# Groundwater Application Review Summary Form

Application # G- 19408

GW Reviewer Phillip I. Marcy Date Review Completed: 01/12/2024

**TO:**            **Application G- 19408**

Cross-Section

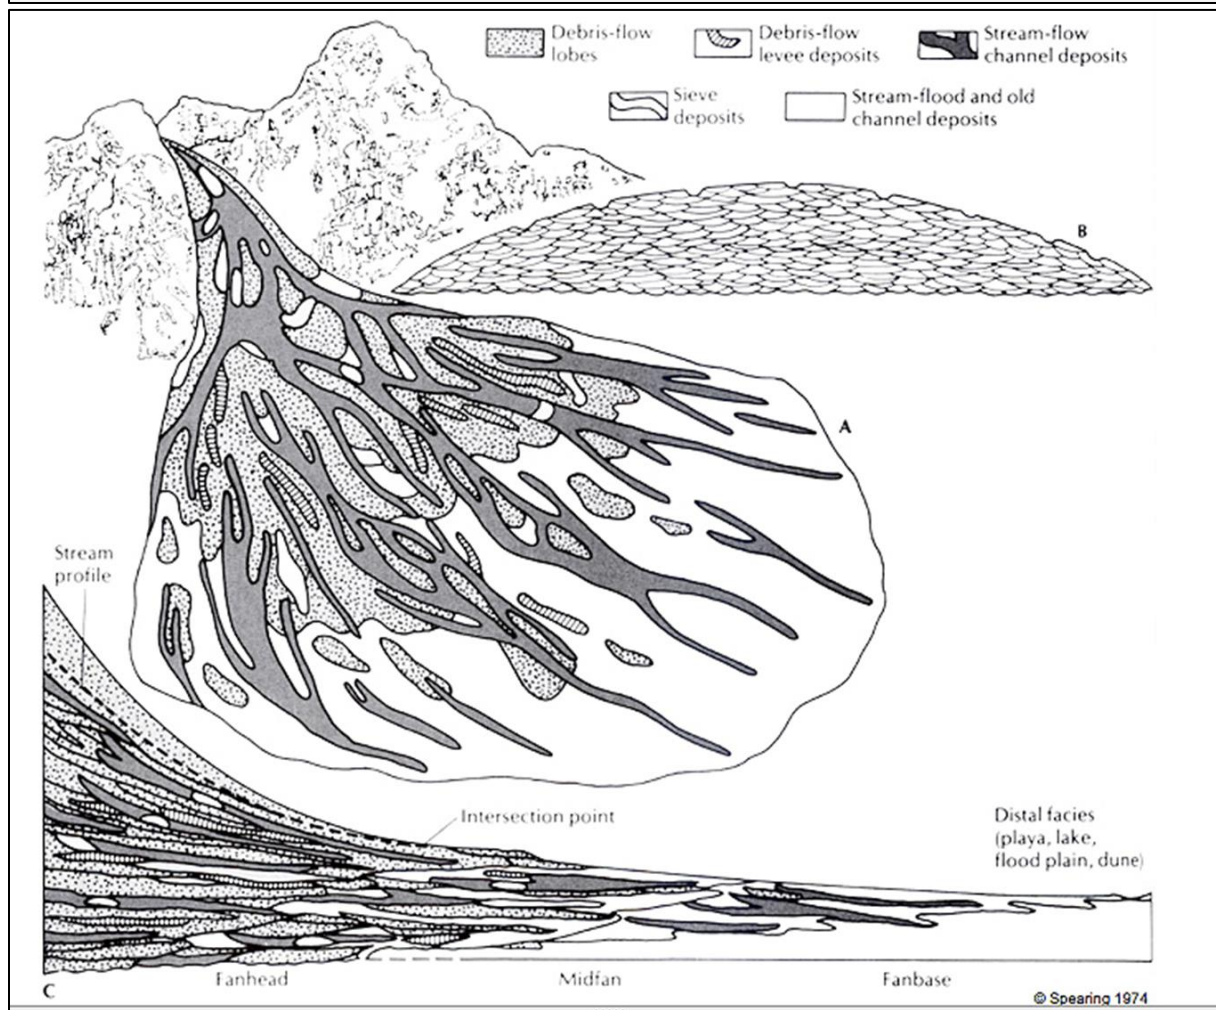
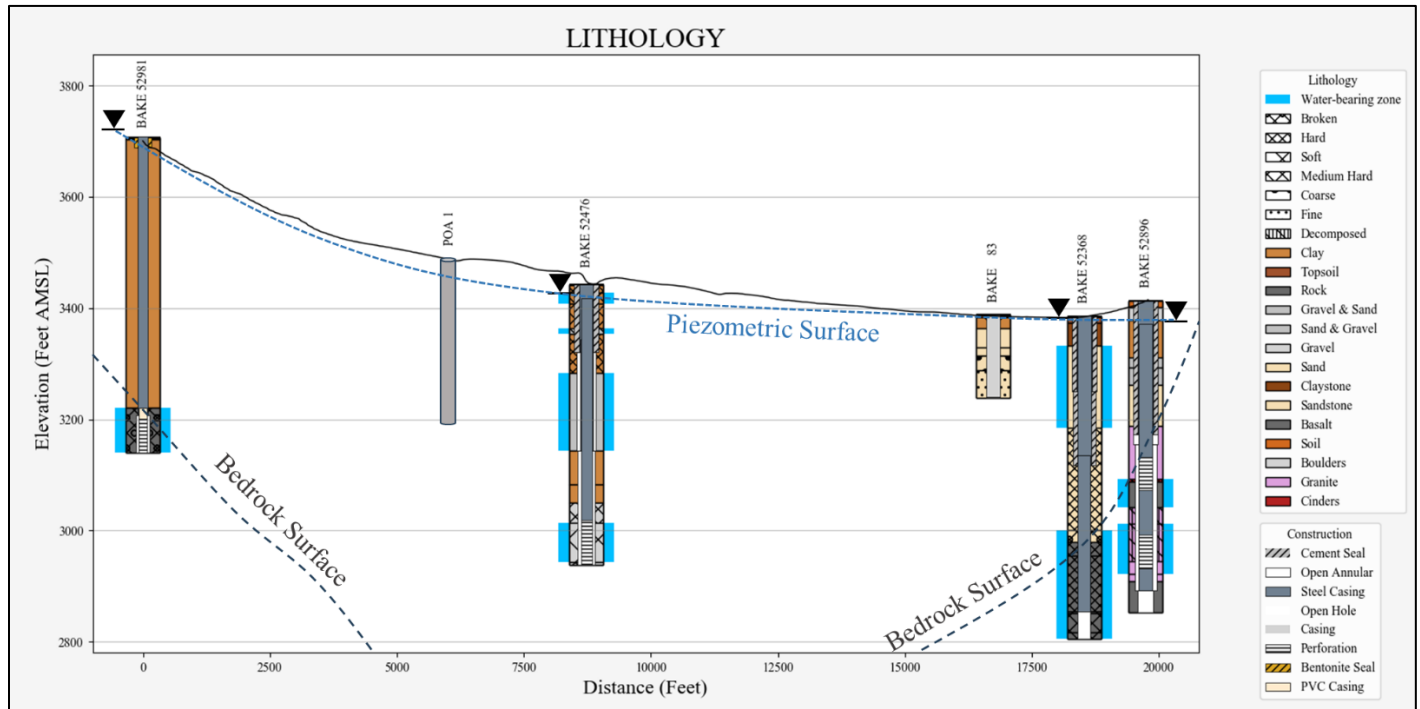
**Basis for aquifer hydraulic connection evaluation:** Groundwater elevations in the vicinity of the proposed development roughly mimic surface topography, and as the water table approaches the valley floor the hydrologic gradient shallows and groundwater begins to discharge where the piezometric surface intercepts land surface. Due to the nature of alluvial fan deposits, there are no known laterally continuous barriers to groundwater migration toward land surface.

**Water-Level Measurements in Nearby Wells**

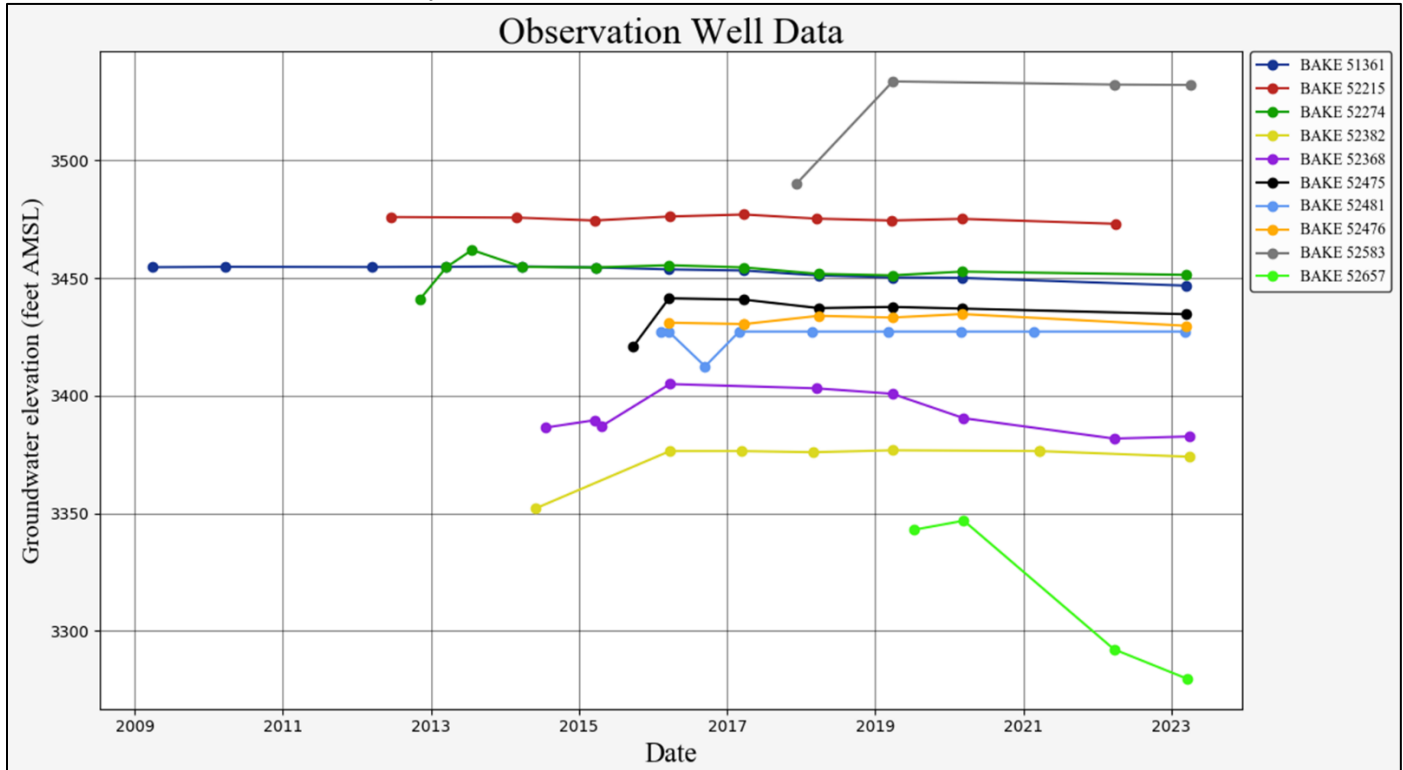
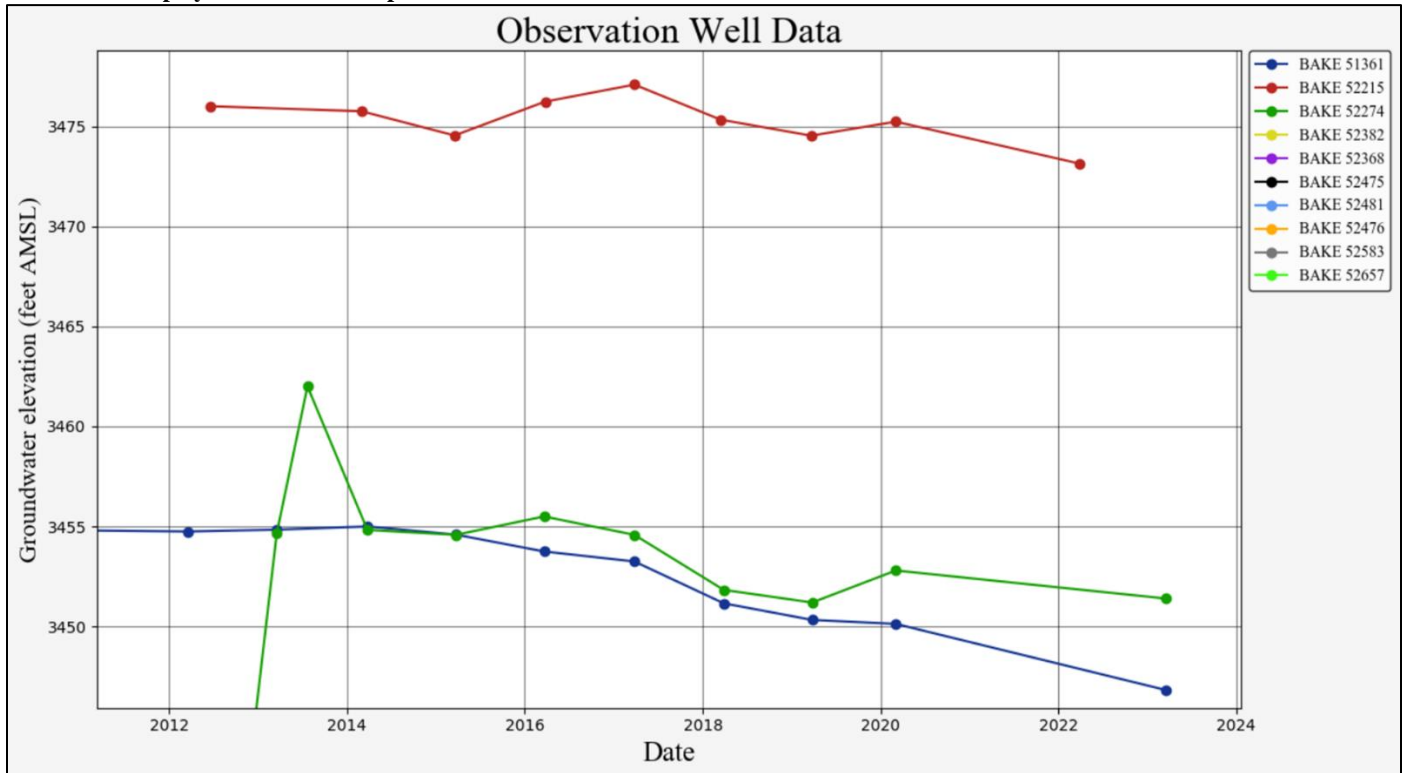
B3. **Groundwater availability remarks:** Permit condition measurements from nearby wells indicate relatively small declines in recent years (see attached hydrograph and map). The position of these and the proposed POA wells in this application are on the bajada along the western side of the Baker Valley, producing from coalescing alluvial fan materials. Hydraulic connection to nearby wells located along the slope of the fan may be highly variable, depending on the orientation and geometry of coarse-grained channel facies at depth, and is typically limited while impacts are inevitably felt downgradient as groundwater that would inevitably reach the valley floor is intercepted by pumping at these locations. Therefore, excessive interference with nearby groundwater rights in not anticipated.

Notable in the observation well data is that wells higher on the alluvial fan display greater declines year upon year than wells near the valley floor. This indicates that the gradient, and thus the volume of groundwater flowing toward the valley has been reduced in recent years according to our conceptual model. While the current dataset may not be sufficient to establish the cause of these declines or the period over which they have occurred, it does establish a need for caution going forward, as once all rights issued in this area are developed, declines are likely to increase and groundwater shortages are likely to be exacerbated.

Water levels near the proposed POA locations generally mimic surface topography and do not display steep declines. Hydrograph colors match those displayed on location map.

Wells at similar elevations to the proposed POA wells report moderate declines since 2014.
